CIRCULATE TO:-		TECHNICAL INFORMATION				
SERVICE MGR.	<input checked="" type="checkbox"/>	SUBJECT 'E' Post Trim Area - Water Ingress		issue 2		
RECEPTION	<input checked="" type="checkbox"/>					
WORKSHOP	<input checked="" type="checkbox"/>					
PARTS	<input checked="" type="checkbox"/>					
MODEL		AFFECTED VEHICLES				
Discovery		LP				
		LH				
		LJ	081991 onward			
		LD				
<p>DETAIL</p> <p>Investigations have shown that on some vehicles water can enter into the vehicle around the 'E' post, there can be several causes for water ingress in this area, all known water ingress paths and fixes are detailed on the flow chart attached.</p>						
<p>ACTION REQUIRED</p> <p>Upon customer complaint of water ingress around the 'E' post, follow the flow chart overleaf.</p>						
<p>PARTS INFORMATION</p> <p>Not applicable</p>		<p>ILLUSTRATION</p> 				
<p>PROCEDURE</p> <p>See flow chart overleaf</p>		<p>WARRANTY</p> <p>Normal warranty policy and procedures apply</p>				
		<table border="1" style="margin-left: auto;"> <tr> <td style="padding: 2px;">COMP. CODE</td> </tr> <tr> <td style="text-align: center; padding: 2px;">9L4N</td> </tr> </table>			COMP. CODE	9L4N
COMP. CODE						
9L4N						
		<p

WATER EVIDENT IN 'E' POST AREA-DIAGNOSTIC CHART

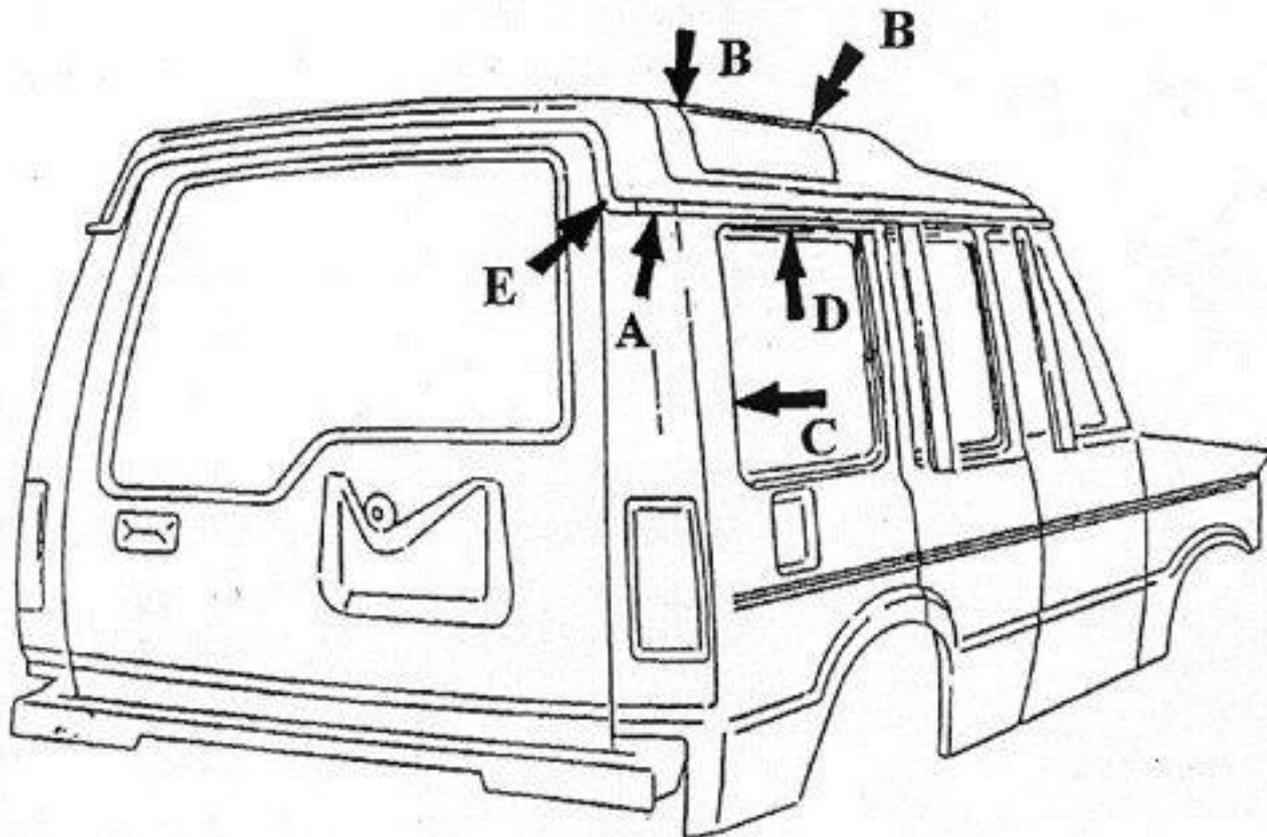
Water drips from alpine light
(see illustration, arrow B)

Check fixed glass sealing and reseal as
necessary (see illustration arrow C)

Check for cracks around flange see 'E' on
illustration; reseal each side of flange.
The flange has been moved inside can't
rail to improve water ingress concerns from
Vins 199607 and 530346.

Reseal alpine light glass to rubber and rubber to
body on outside surface

*Remove quarter trim and alpine light trim. *Visually check for evidence of leak. *If necessary hose water over roof / rear header / alpine light / fixed glass		
Continue		
Water drips from cantrail inner near 'E' post		
Continue		
Hose water onto roof driprail only Is leak still evident?		
Yes	Yes	No
Remove the drip rail trim. Dam the roof drain channel above the B-C post. Fill driprail with water behind dam then repeat with water in front of dam. When does leak occur?	Remove the drip rail trim. Dam the roof drain channel above the B-C post. Fill driprail with water behind dam then repeat with water in front of dam. When does leak occur?	Remove rear header trim Inspect tape and joints for pin holes- reseal as necessary
Continue	Continue	Continue
Water in front of dam	Water behind dam	Double check alpine light sealing
Continue	Continue	Continue
Check roof drain channel for pin holes and reseal as necessary. Do not remove screen. Do not replace screen to repair leak.	Inspect Zinc tape for pin holes and reseal as necessary (see illustration arrow A)	Always water test to confirm resolution -There may be other leaks! Always dry off joints before applying sealants

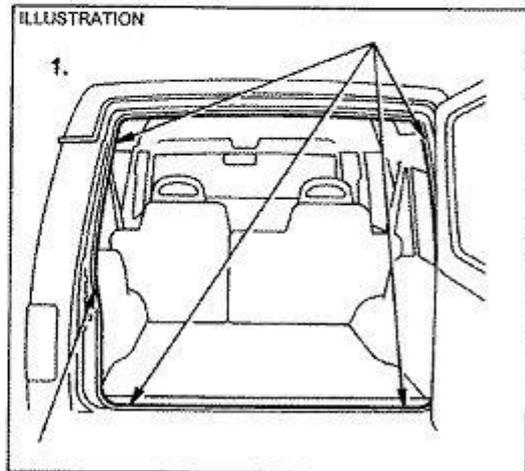
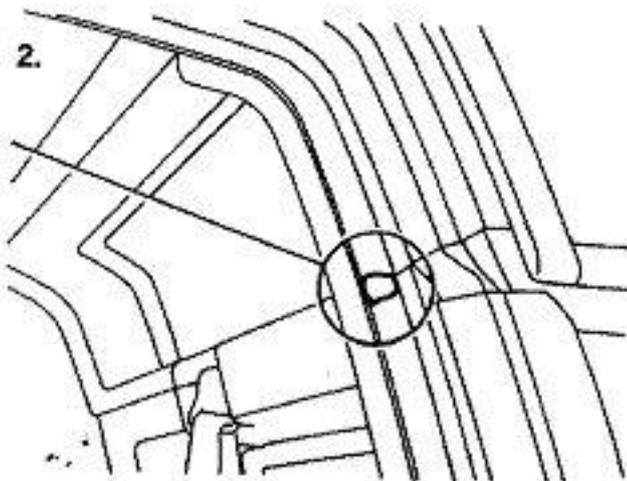
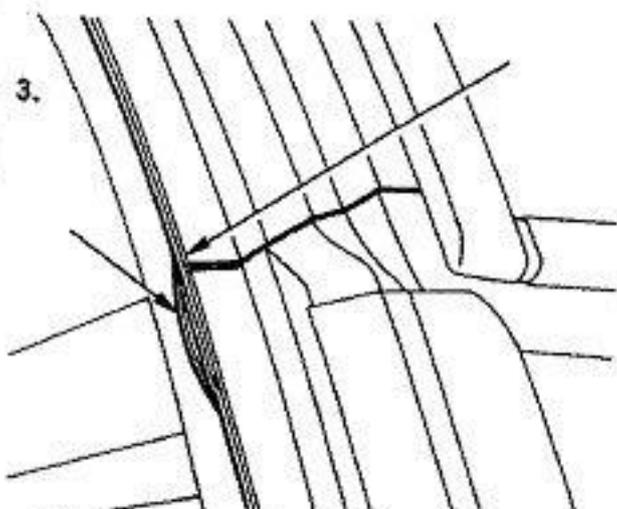
As part of ongoing quality improvements a new double bubble seal has been introduced onto the rear tail door. Early indications have identified a potential water leak from this area due to seals fitting incorrectly on a misformed seal flange. Investigations by Land Rover engineers have found that following procedure overcomes this issue on all vehicles.

1. Remove rear end door tread strip.
2. Remove rear end door seal from failed vehicle.
3. Using a craft knife, cut any excess trim tape that has been wrapped around the rear end door aperture see illustration 3.
4. Dress any flanges that appear to have panel mismatch to obtain a tight finish see illustration 1&2.
5. Smooth in Butyl around the four areas where the panel meets and form a channel to obtain a smooth finish for the foam tape see illustration 1&2.
6. Carefully apply the foam tape around the aperture as close as possible to the edge of the panel. Remove backing paper, smooth out, avoid any creases see illustration 1.

7. Working in an anti-clockwise direction feed the door seal on by hand, the joint of the door seal must be in the centre of the door aperture at the bottom. Ensure all the corners are of a tightfit and the foam and the trim tape have not been disturbed or snagged. Hammer the door seal onto the aperture tightly.

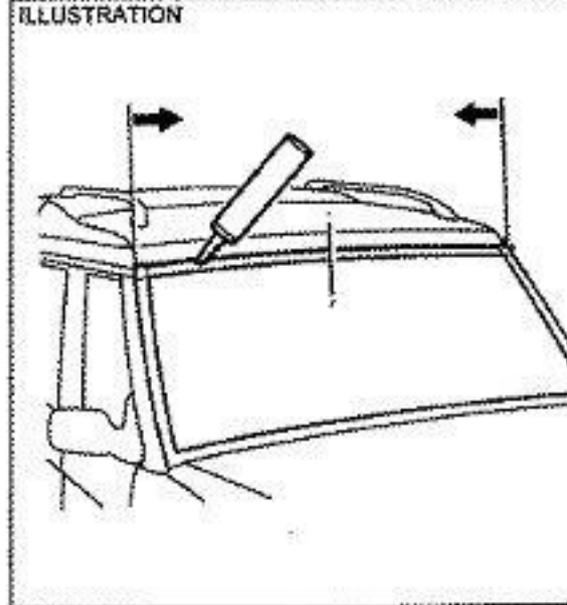
To overcome water ingress through the upper section of the windscreen seal a process has been developed to introduce a supplementary sealing operation behind the seal. Should a vehicle exhibit water ingress this area follow the procedure below.

Peel back the windscreen rubber at the top for access.
Thoroughly clean area to be sealed using cleaner provided.
Locate sealant nozzle between top windscreen rubber and roof panel, extrude bead of sealant (continuous) from the centre of the vehicle towards the corners (see illustration opposite).
Finish sealing in the corner.
Clean off any access sealant from the windscreen/ rubber and paint.

Care point: angle the sealant away from the painted panel.

MODIFIED GUIDE TUBE (ILLUSTRATION A)

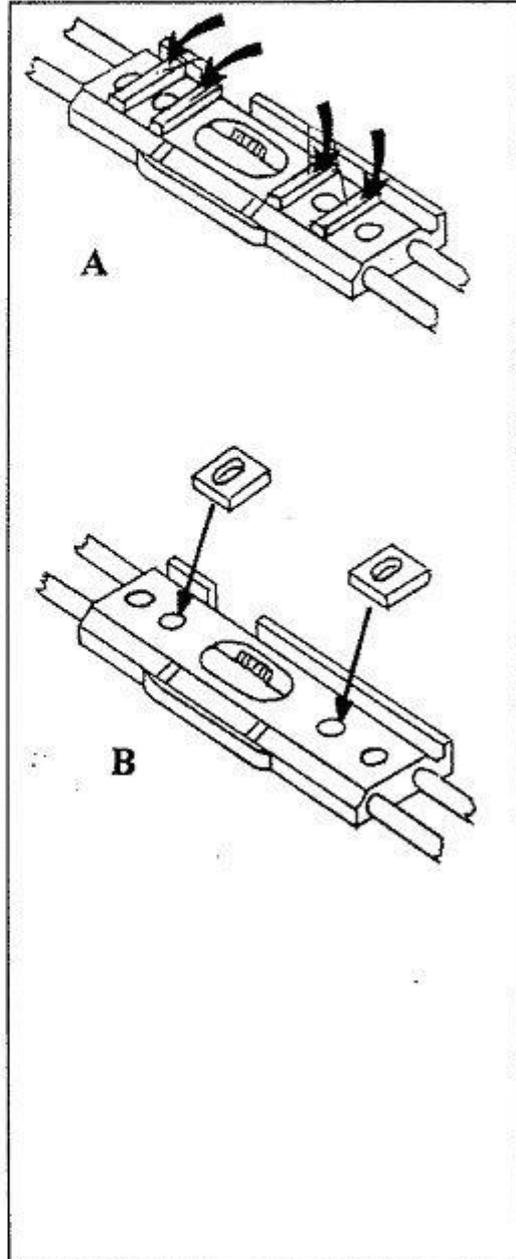
Following recent improvements to the sunroof lower tray STC 1686 and the guide tube assembly STC 1683, a spacer kit Part No STC 3194 (containing 4 white spacers) will be required if either the sunroof lower tray or the guide tube assembly are changed in vehicles prior to the Vins given.

When fitting a modified lower tray to an unmodified guide tube x 2 spacers must be fitted to the guide tube.

Gently lift the guide tube assembly off the two locating pegs on the upper frame to gain enough clearance to insert the spacers over the two inboard holes as indicated then reseat the guide tube assembly.

MODIFIED LOWER TRAY ILLUSTRATION 'C'

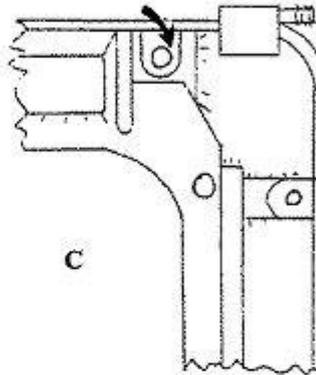
Underside view look for 'U' shaped impression around corner hole as shown opposite.

ILLUSTRATION 'E'

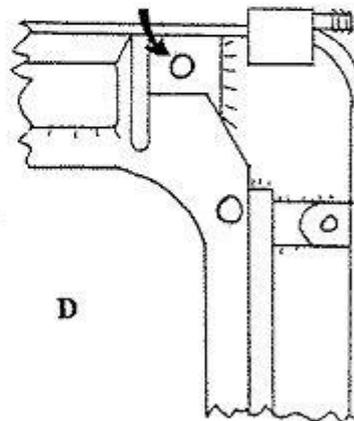
Fit x 4 spacers as indicated opposite to the inside of the lower tray.

When fitting a modified guide tube assembly to an unmodified lower tray x 4 spacers must be fitted to the inside of the lower tray as indicated opposite.
